ASSESSMENT REPORT			
Unique Document ID and Revision No:	ONR-OFD-AR-18-016 Revision 0	TRIM Ref:	2018/202683
Project:	Heysham 2 Reactor 7 2018 Periodic Shutdown		
Site:	Heysham 2		
Title:	Heysham 2 Reactor 7 2018 Periodic Shutdown: Structural Integrity Assessment of the Graphite Core Inspection Findings, including Consideration of EC 356531		
Nuclear Site Licence No:	588		
Licence Condition(s):	30, 28		
ONR Assessment Rating (Mandatory): <i>(Rating should be based on licensee's original safety case submission)</i>	GREEN		
COIN Service Order:	SVC4285368

**Heysham 2 Reactor 7 2018 Periodic Shutdown – Assessment of the results of the
Graphite Core Inspections**

Assessment Report ONR-OFD-AR-18-016
Revision 0
29 June 2018

Figure 3: Circumferential crack observed in fuel channel K35, layer 8 (Reference 26).

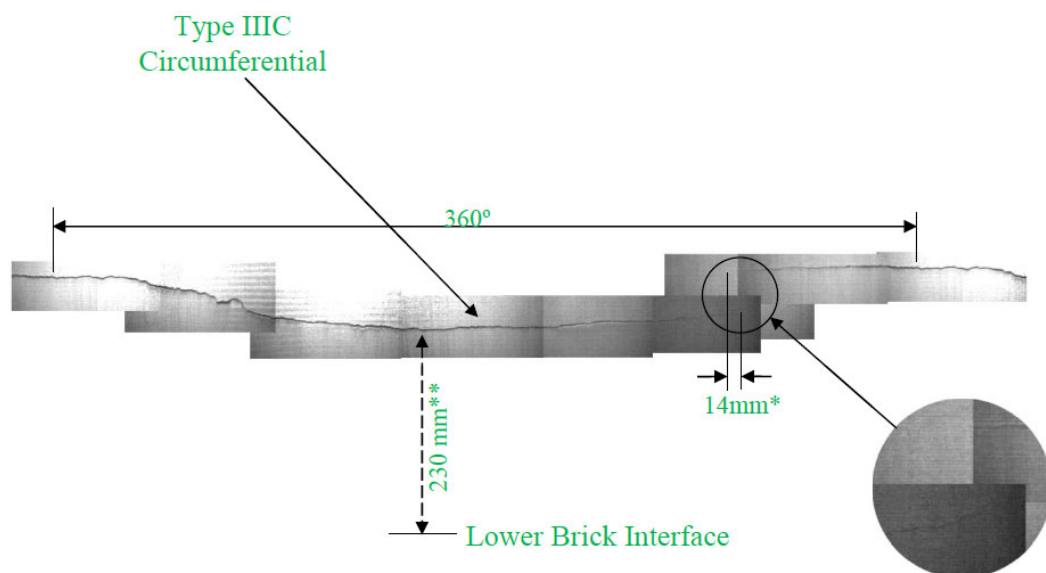
50. The brick and channel distortions measured were within expectation. The control rod channel did not reveal any defect. The results of these inspections are therefore as expected and do not challenge the assumptions of the safety case.

- 51. This is the second circumferential bore crack observed in the HYB R7 graphite core (see Table 1 of Reference 15). No full height axial crack has yet been observed in this reactor although two smaller cracks have been observed ('Type IIIA' as per Table 1 of Reference 15). I therefore consider that the results of these inspections do not challenge the licensee's 'intact core' definition, i.e. 10% cracking.

Figure 4: Core distortion map calculated using Core Distortion Pinning program.

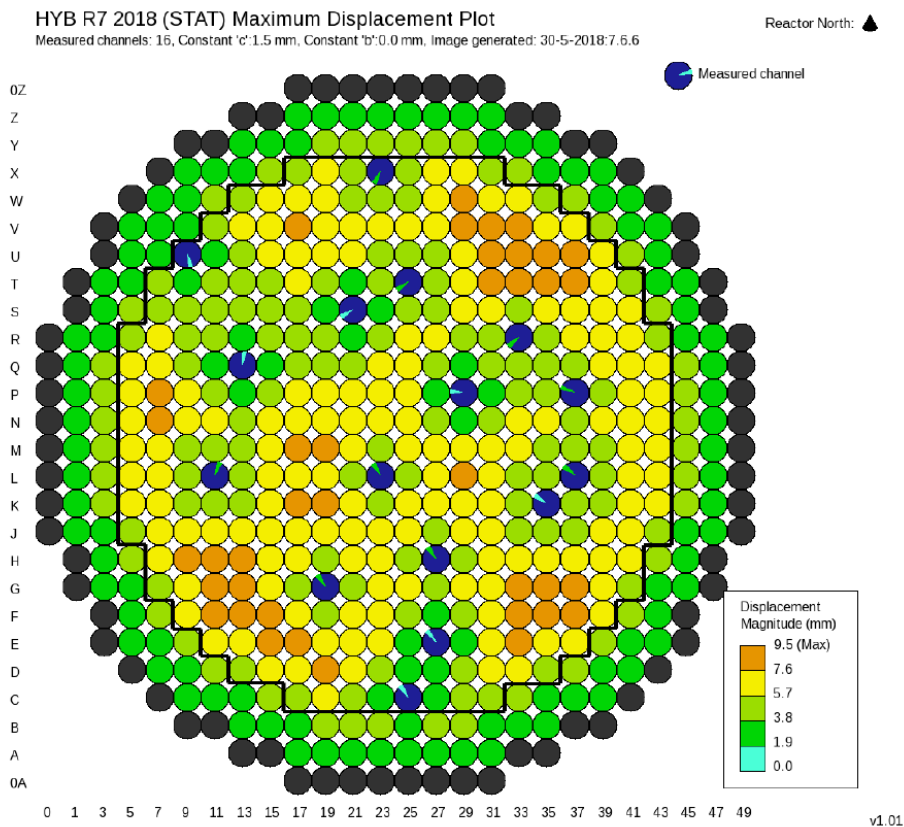
- 53. The displacements in Figure 4 show that the channel displacement relative to the base layer is generally less than 9.5mm. Measured core distortions of channel tilt and bow appear to be similar, or not significantly worse, than previous core measurements. Therefore, I do not expect this level of distortion to be a concern for the safety of the core.

Figure 5: Peripheral Wall Inspection W092/05 – Layer 3, Face 16, Brick 8: example of 'missing graphite'.

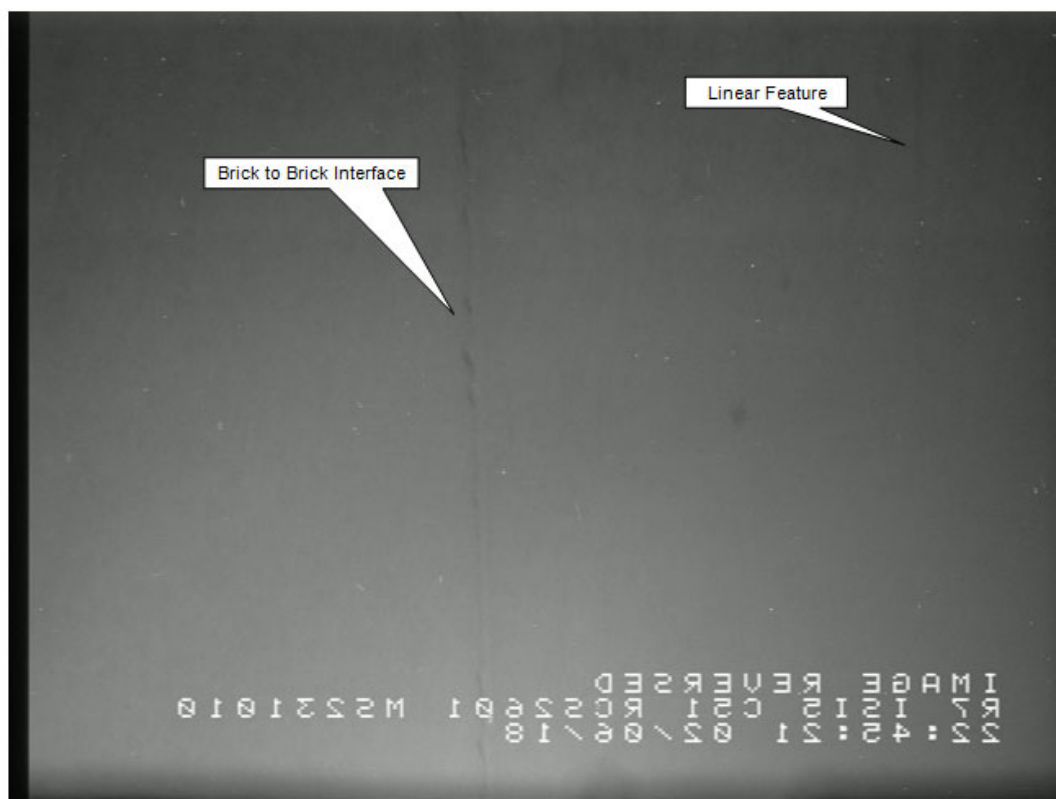
64. Figure 5 shows eroded pieces of graphite at the interface between the peripheral wall bricks. This was classified as 1.8 (linear feature) by the PBAP. During the meeting, I asked the PBAP members for clarification concerning the missing pieces of graphite. NGL explained that the size of the missing edges of the graphite brick was small, ~0.5mm, and noted that it was most likely a machining mark or a scratch. The PBAP did not consider this to be significant and confirmed that a classification of 1.8 was appropriate.

65. In my opinion, the resolution of the camera does not allow for a definitive conclusion to be drawn. However, I consider that these defects are small and do not present a crack-like feature. I therefore do not consider that these are likely to be of any significance for the integrity of the core.

Figure 6: Peripheral Wall Inspection W108/02 – Layer 1, Face 11, Brick 7: linear feature.

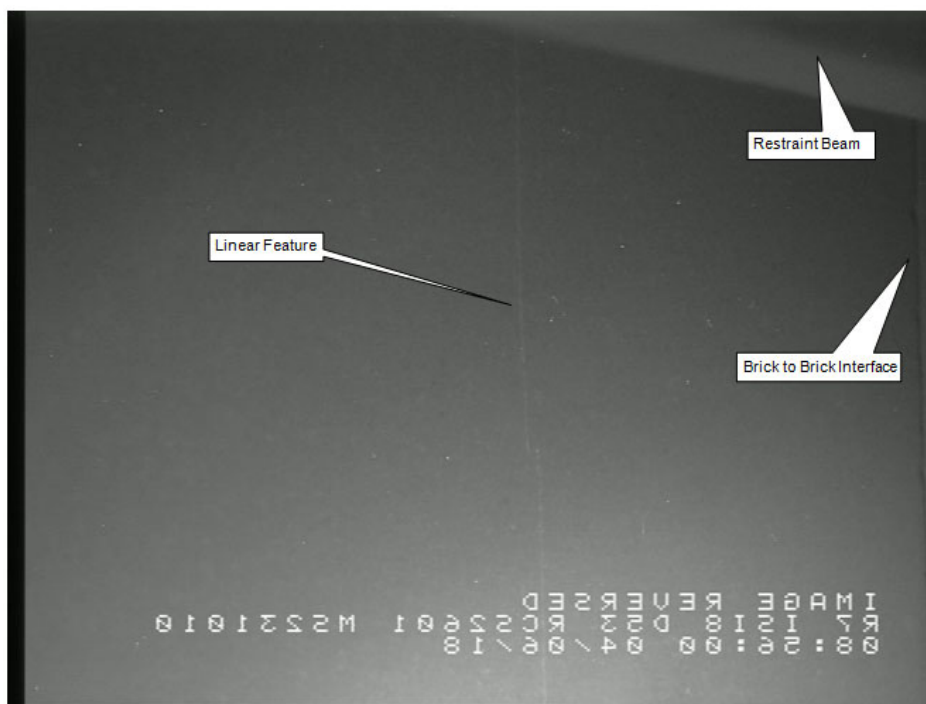
68. The two defects shown in Figure 6 are relatively straight and do not seem to exhibit a marked thickness through the brick. Also, the two marks do not join up and abruptly stop at a very close distance. This suggests that there is no active mechanism to drive the defects to join up. I therefore conclude that the features shown in this figure are unlikely to be cracks and that machining marks or score marks during installation could be a possible cause for these defects. As a comparison, Figure 7 shows a linear crack (inspection sheet W081/02 in Reference 28).
